485 Golf Links Road, LANGWARRIN SOUTH

Planning Permit Application

Application No. PA2302502

Officer Assessment Report
Development Approvals & Design

Figure 1. Proposed aerial view (left) Figure 2. Proposed building materiality (right)

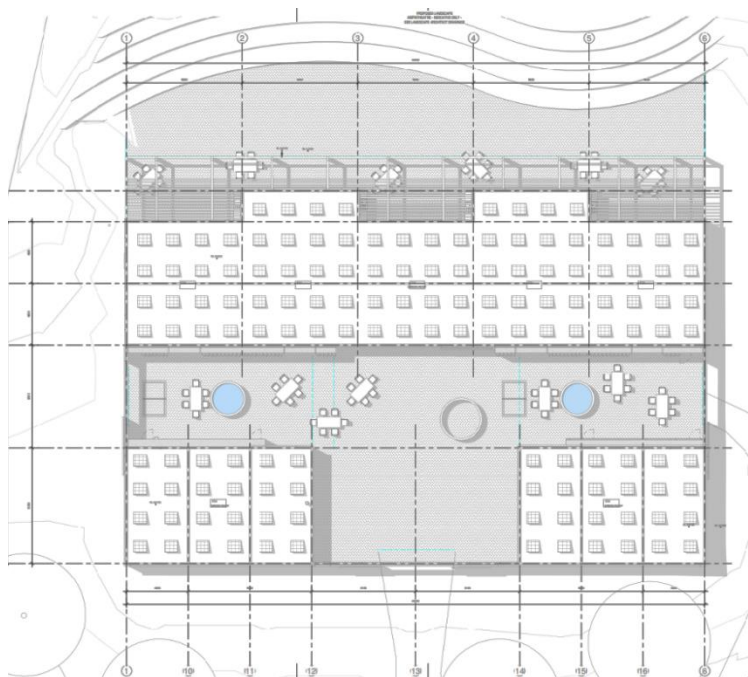
- The year 10 area will consist of three single-storey buildings connected by a central integrated outdoor learning space. Figure 1 shows that the three buildings comprise of five classrooms (74-87m²), two breakout meeting rooms (14m²), a coworking/homestead space (84m²), a staffroom (85m²) and student and staff toilets. There is also a shaded deck along the northern elevation that provides additional outdoor learning spaces.

4. The proposed building seeks to include the following ESD features:
- Use of agroforestry timbers
 - Green roof for insulation and enhanced efficient thermal cooling/heating
 - Rooftop solar panels (figure 1)
 - Use of recycled brick
 - Use of double-glazed windows
 - Substantial planting of native vegetation including trees to be planted north of the development
 - On-site wastewater treatment plant, for the capture and reuse of water
5. The 51 native trees proposed to be removed as discussed above are planted vegetation and therefore exempt from Clause 52.17 (Native Vegetation), however still trigger the requirements of Clause 42.02-2 (Significant Landscape Overlay) as planted vegetation is not exempt from a permit requirement to lop or remove.
6. The applicant has provided the following concept image/s of the proposal:

Figure 9. Ground Floor Plan (top)
Figure 10. North and south elevation (bottom)

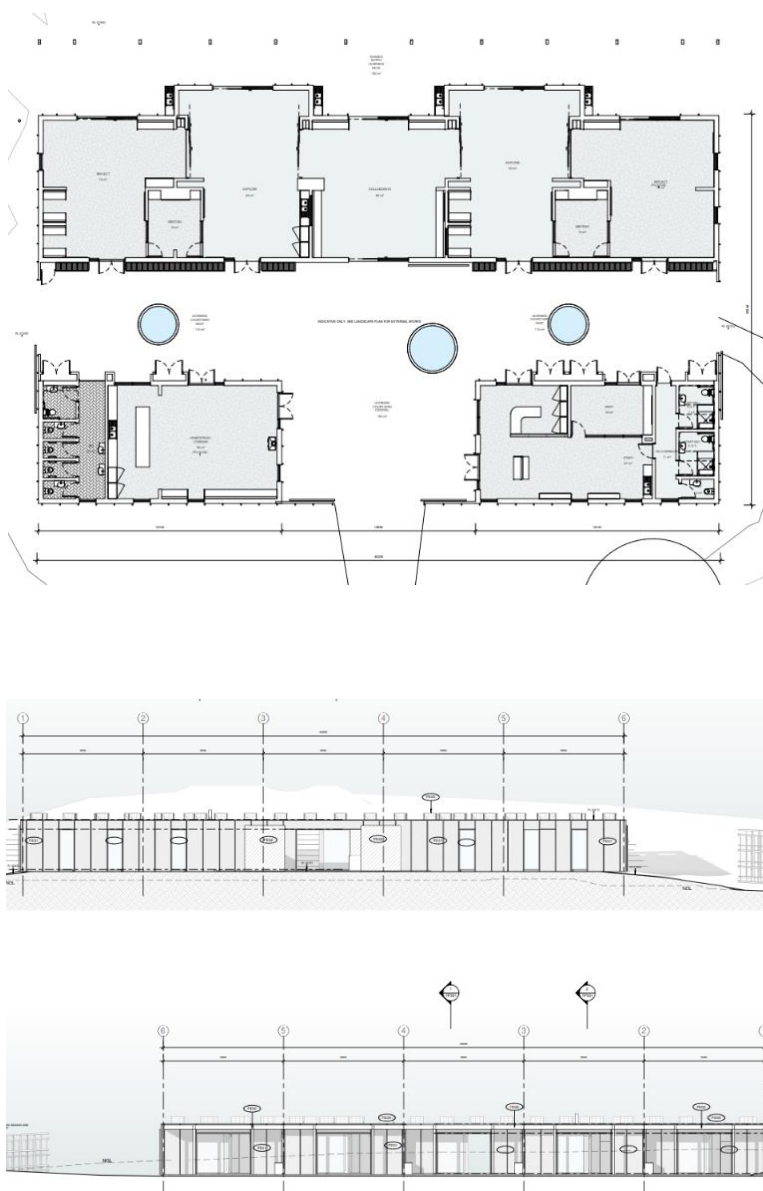
- The shared open courtyard and split of the development into three smaller forms further emphasise the focus on the surrounding environment by breaking the massing (figure 9).
